D. P. & L. G. CARR B104 / 7 Skyline Place, FRENCHS FOREST, NSW 2086

Re: Development Application No. DA2025/0151
Lot 11 DP1258355, 5 Skyline Place, FRENCHS FOREST NSW 2086
Proposed Child Care Centre in an Approved Mixed Use & Seniors Development

"B"

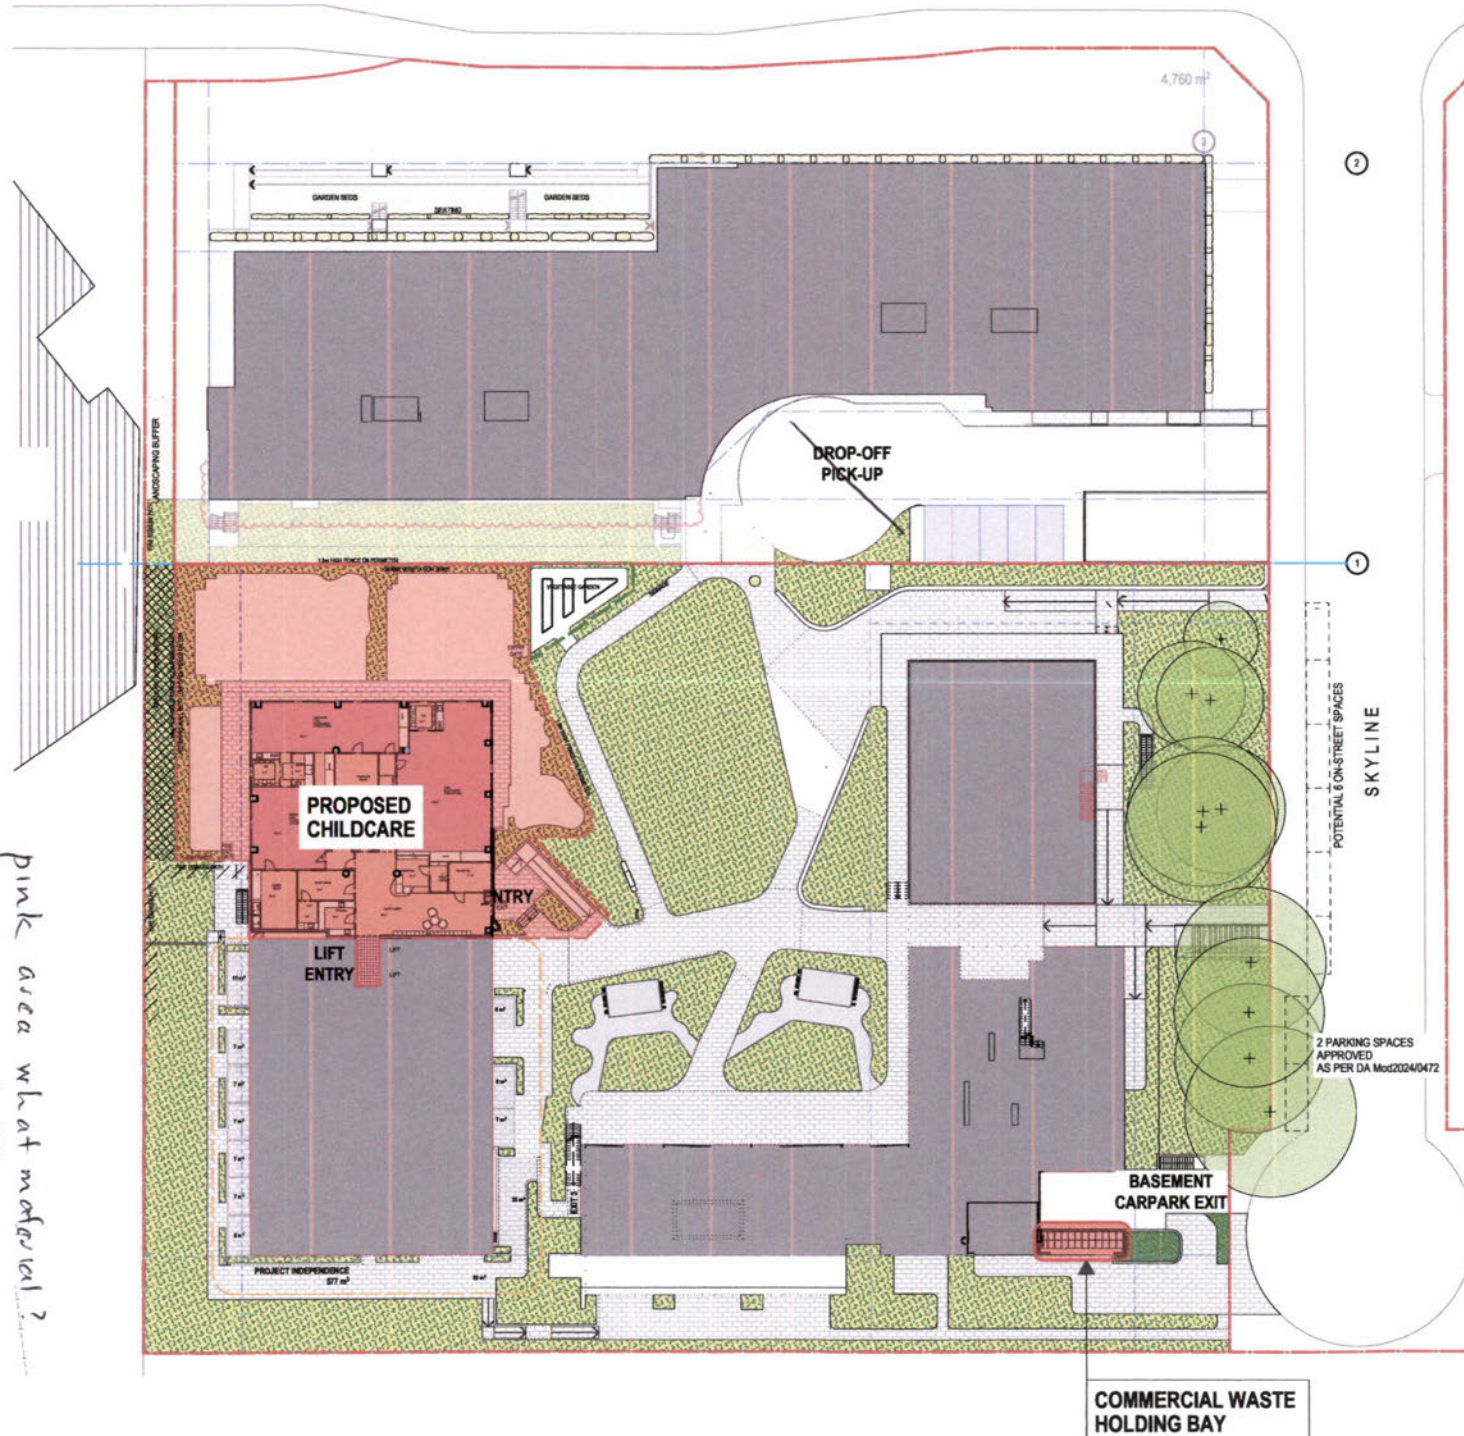
- d) The shade material should not reflect glare towards no. 7 Skyline Place.
- 2) **Grass or manufactured fake grass matting?** Again **no details**. Stormwater issues if fake grass.

- 3) **Reduction in the size of landscaped areas.** COMPARE Plan "C" with Plan "B"
 - a) **To the west**, the landscaped buffer area is reduced in size by the provision of additional play space, which will surely be hot in summer and cold and windy in winter, as is similar space at the western end of no. 7. The western buffer has an important role in privacy for the children at the Centre and protection from cold winter westerlies.

- b) **To the north**, the buffer zone is labelled "Dense vegetation zone" but its depth is shown as less than a single door width. The depth of this landscaped area must be increased otherwise the "Dense vegetation" may well be limited to a vine on the fence!

pink area what material?
grass or what?
western buffer zone reduced

"C"

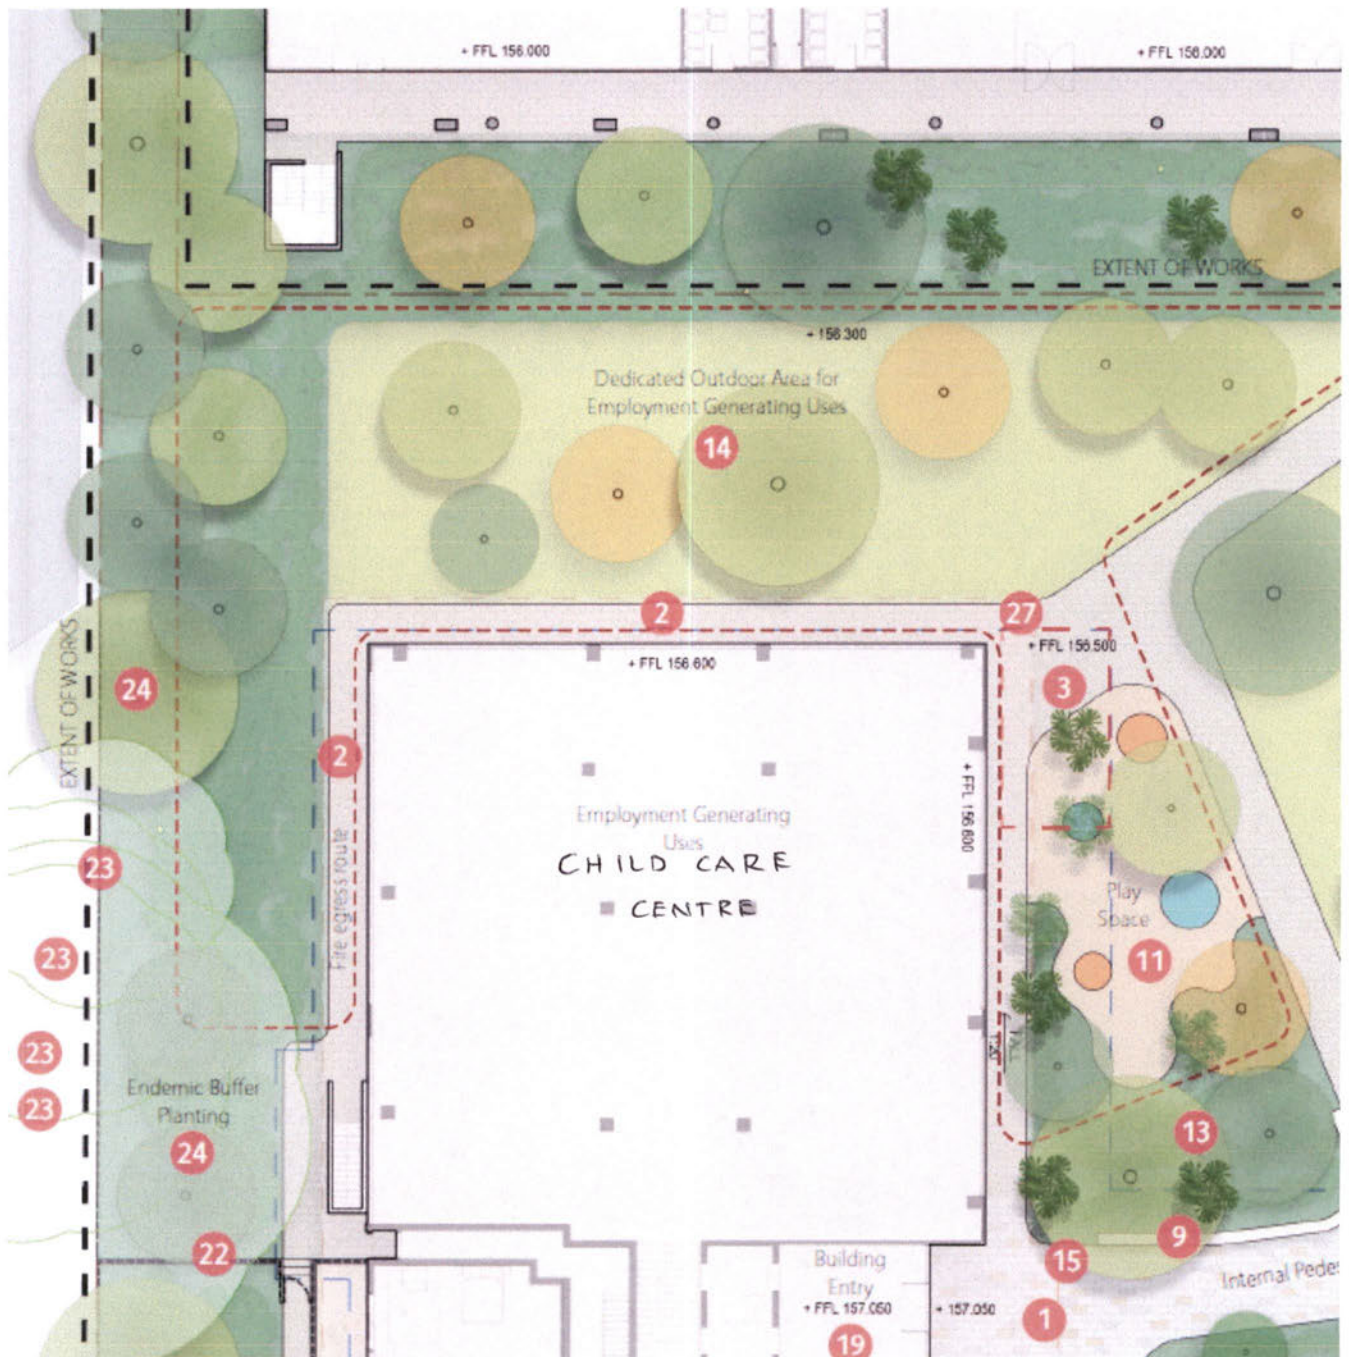
Extract from Mod2024/0472 plans.

- 14 Grass + trees
- 24 Buffer planting
